Comments from LLRF

- LLRF performance under large dead time
- Questionnaire

SCRF meeting (Sep.3, 2008)

Operational gain and bandwidth

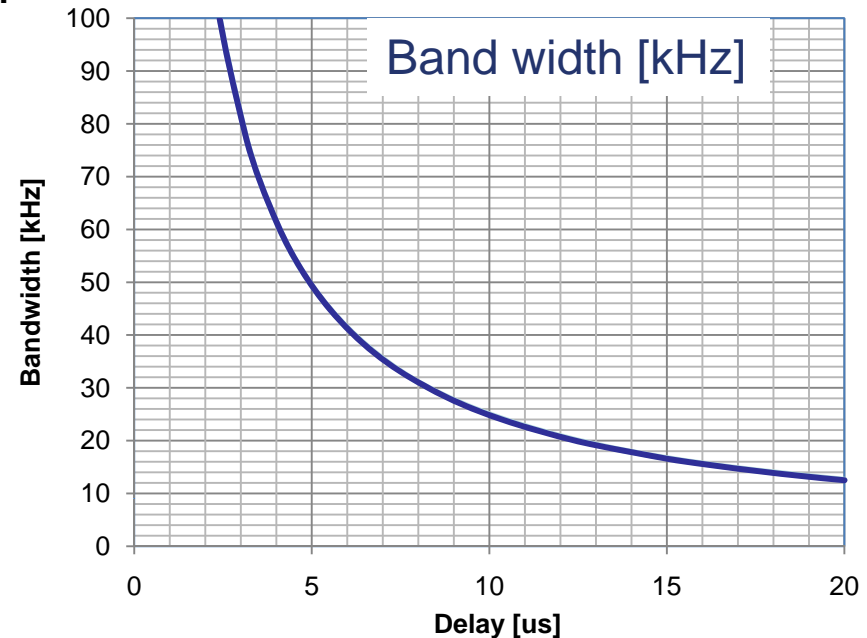
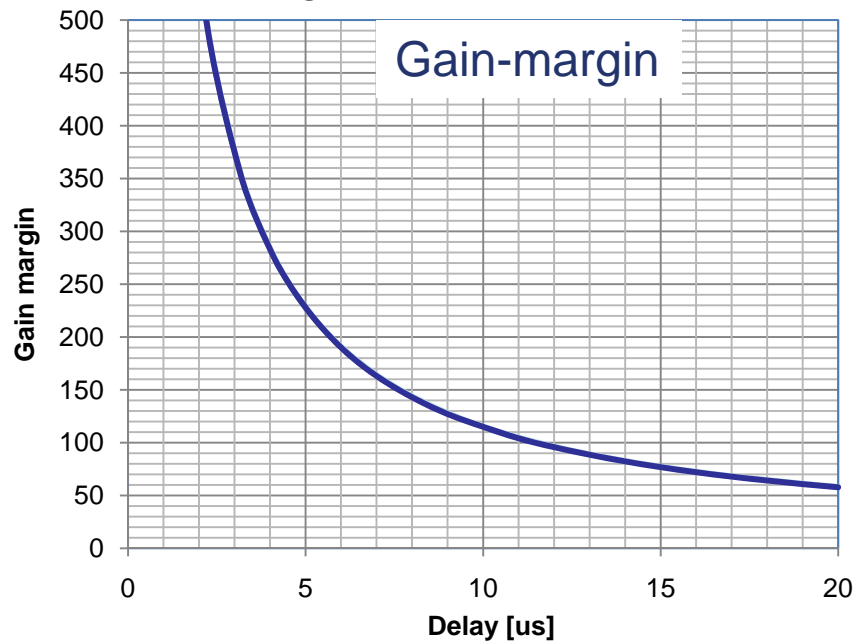
- Error is only compressed by a factor of gain
- Current proportional (P) control + FF is not sufficient due to lower gain
- PI (proportional and integral) control will be necessary
- Gain margin is calculated from Bode-plot.

Step response of Ilrf control

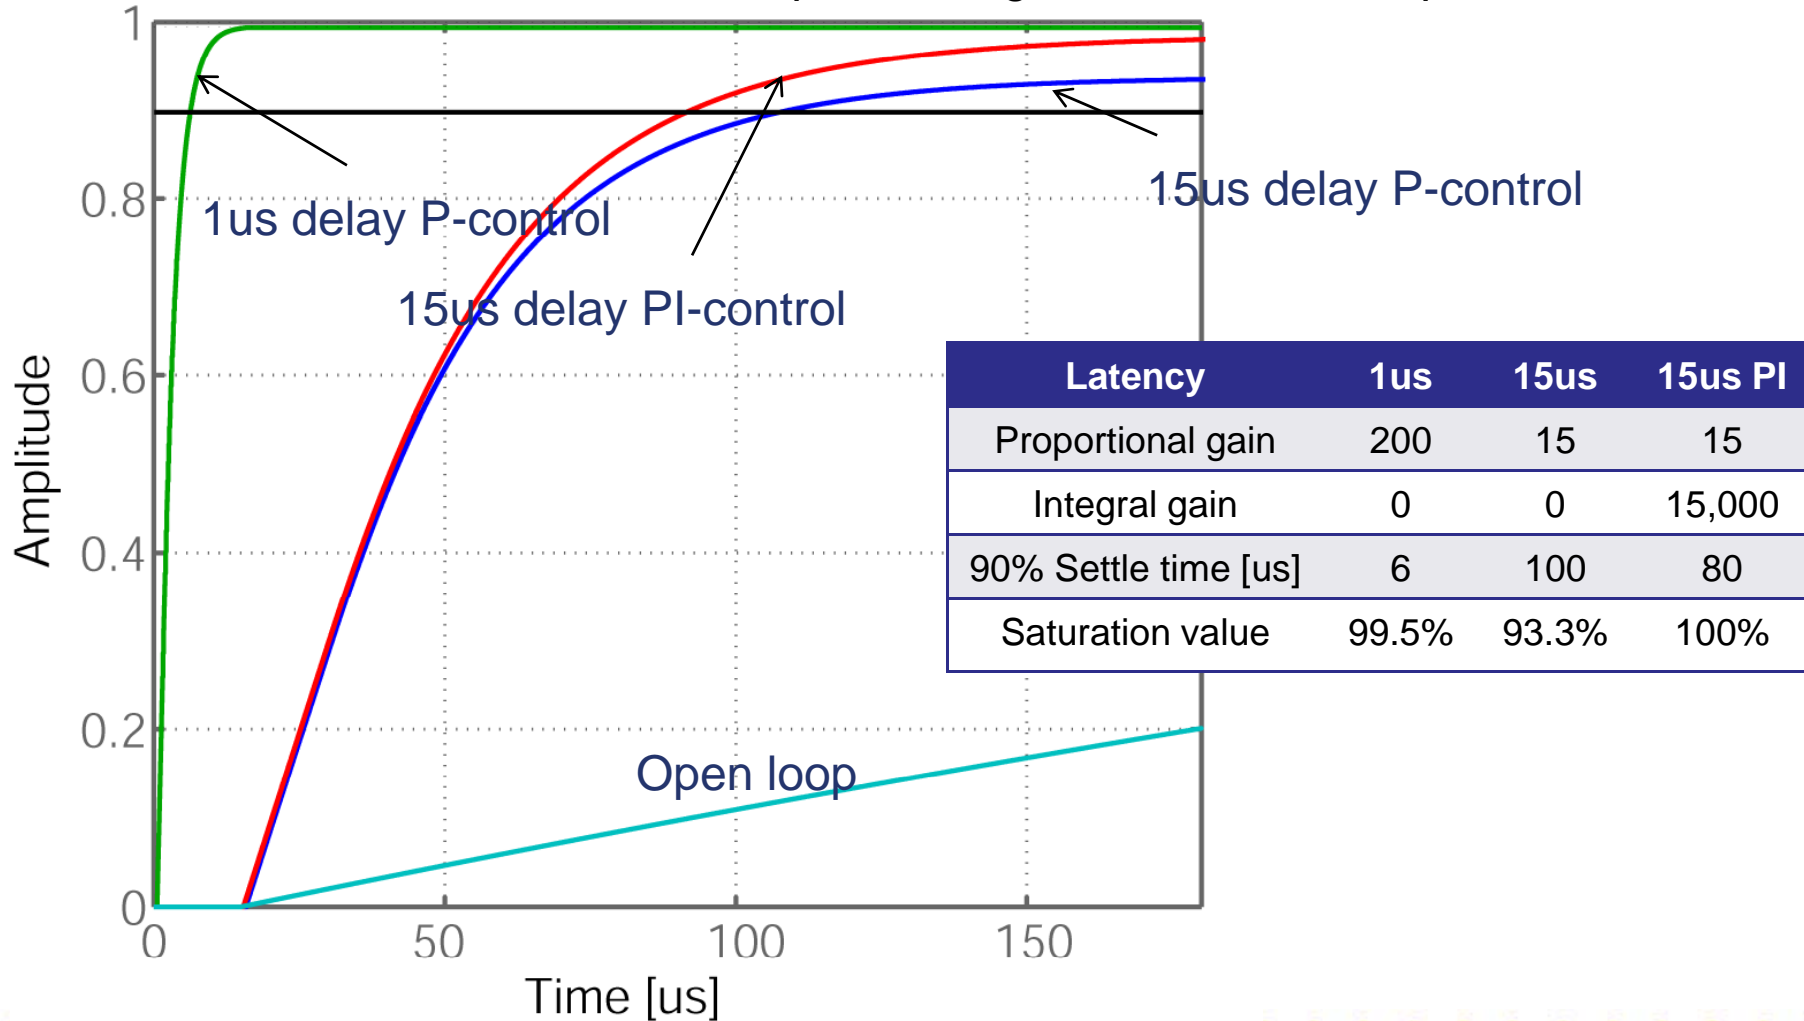
- 15us delayed system has slower response.
- Blind time of 15us and slower response degrades the total FB performance.

■ Example 1: Detuning changes (microphonics or Lorentz force) by 20 Hz (5 deg in phase) during rf operation.

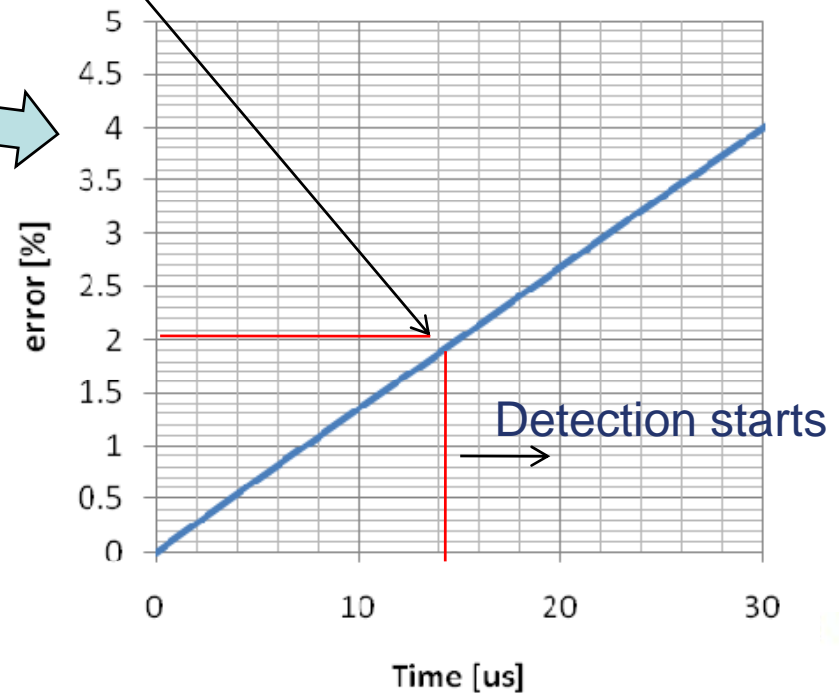
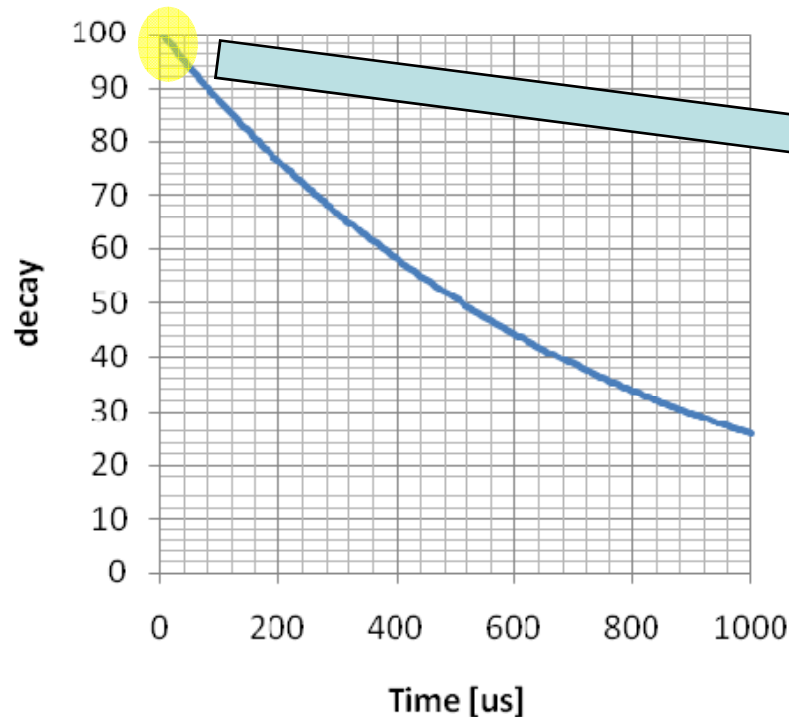
- Cavity phase changes by 0.2 deg . ($= 5 \text{ deg} \cdot 4\%$) and all the error budget is used for this.

FB latency and lrf performance (2)

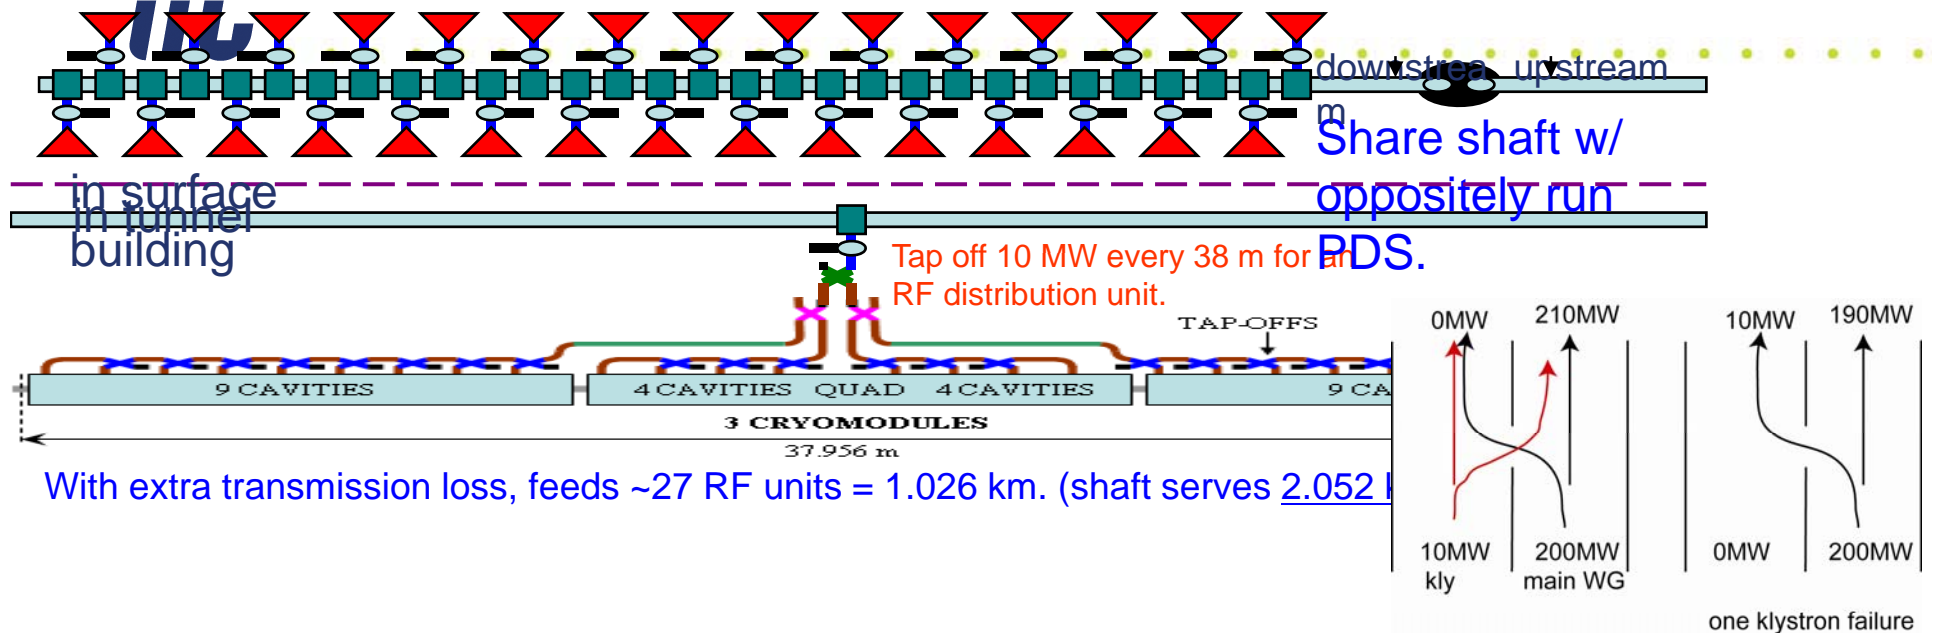
- Example 2: Kly HV change (1%, ~1.25% in amplitude) during rf operation.
 - Cavity amplitude changes by 0.034 % (=1.25%*4%).
- Example 3: Kly HV change (1%, 12 deg. in phase) during rf operation.
 - Cavity phase changes by 0.48 deg. (=12*4%) far from our goal of <0.1deg.
- We can not know the perturbation for first 15us and we need another 1us to detect error and >15us to recover. So total **performance is poorer in case of 15us delay.**
- Despite slow rf time constant of SC cavity, blind time of 15us is large enough for the difficulties in field regulation.
